**TO:** Plan Holders  
LA PATA PARK – PHASE 1B  
City Project No. 18142-A

**SUBJECT:** Addendum No. 2 – Changes to Plans and Specifications  
City Project No. 18142-A

## **ADDENDUM No. 2**

### **LA PATA PARK – PHASE 1B, Project No. 18142-A**

Football Field

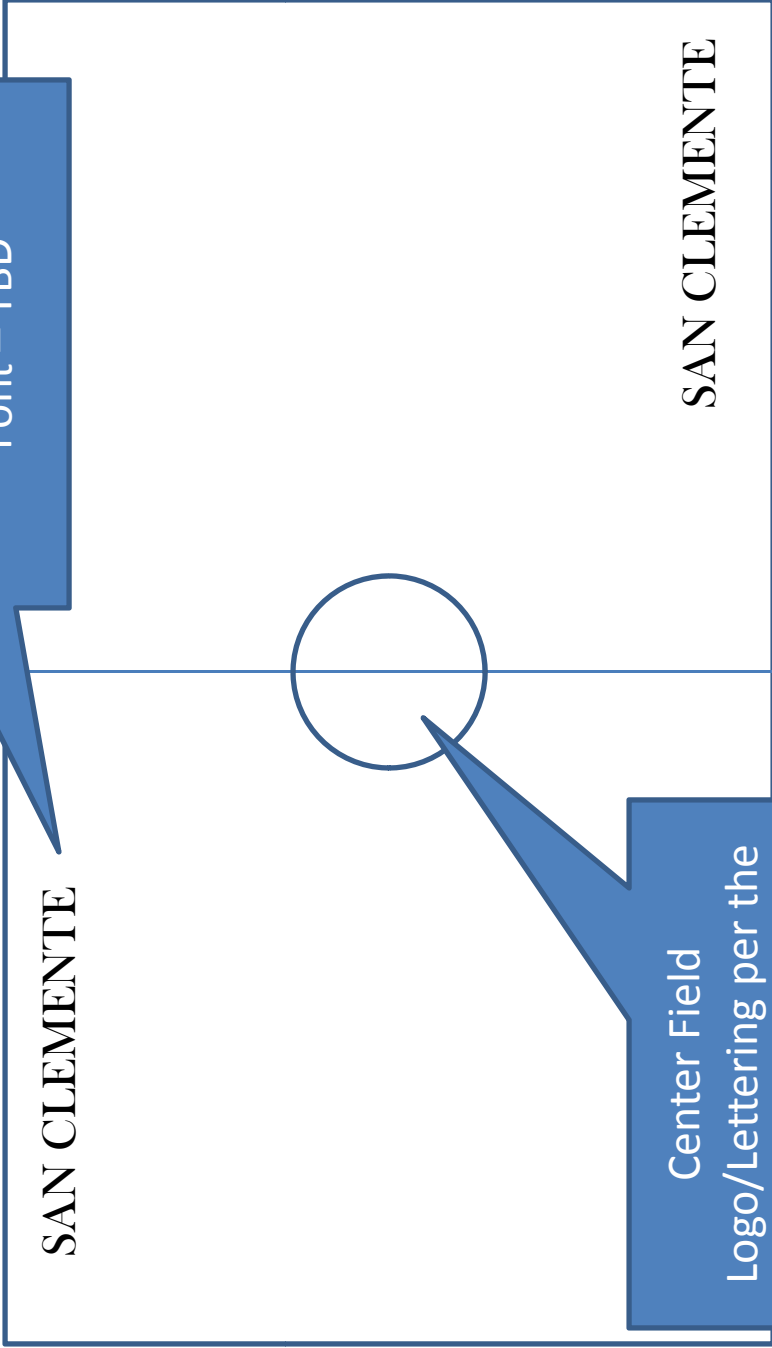
Cross Field Lettering  
Height shall be 10 feet  
Three colors – TBD  
Font – TBD

Center Field  
Logo/Lettering per the  
original plans

Soccer Field #1

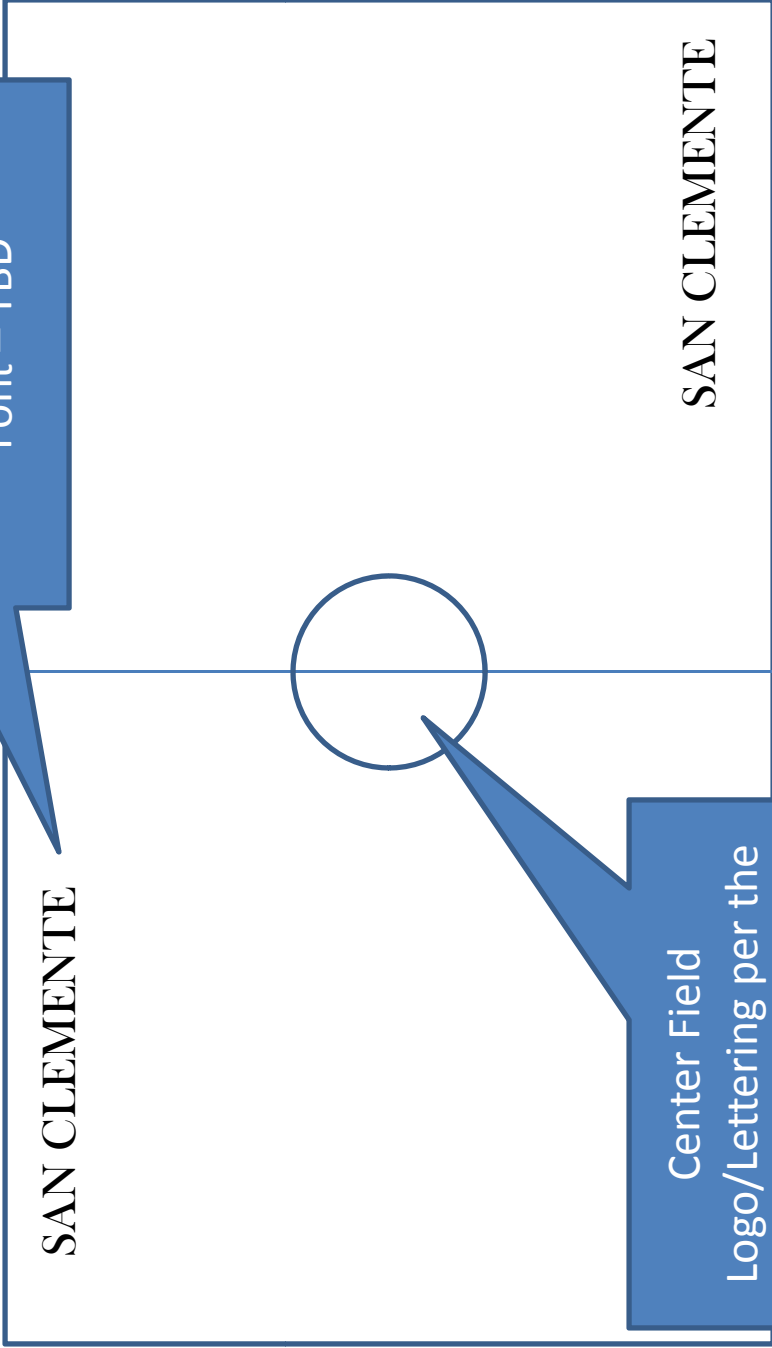
Cross Field Lettering  
Height shall be 10 feet  
Three colors – TBD  
Font – TBD

Center Field  
Logo/Lettering per the  
original plans
